1 Francis Road Lindfield RH16 2JB

Planning application DM/26/0582 – Discharge of Conditions

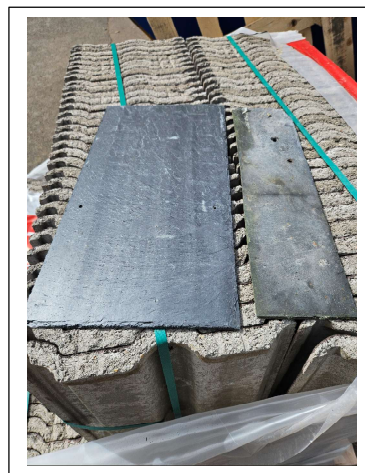
- Fibre cement slates will not be acceptable on a period building in a Conservation Area setting and should be replaced with natural slate. No detail has been provided of the roofing material to the flat roofed extension at the rear?

In the context of the existing porch and main roof covering, the fibre cement tiles will be acceptable, but can the applicant please confirm the colour.

Having taken a slate from the roof it turns out they are indeed natural slate (although exceptionally thin). We therefore propose to use Spanish natural slate with a reference RB27. Here is a photograph with the existing and proposed slate from Brian Gow
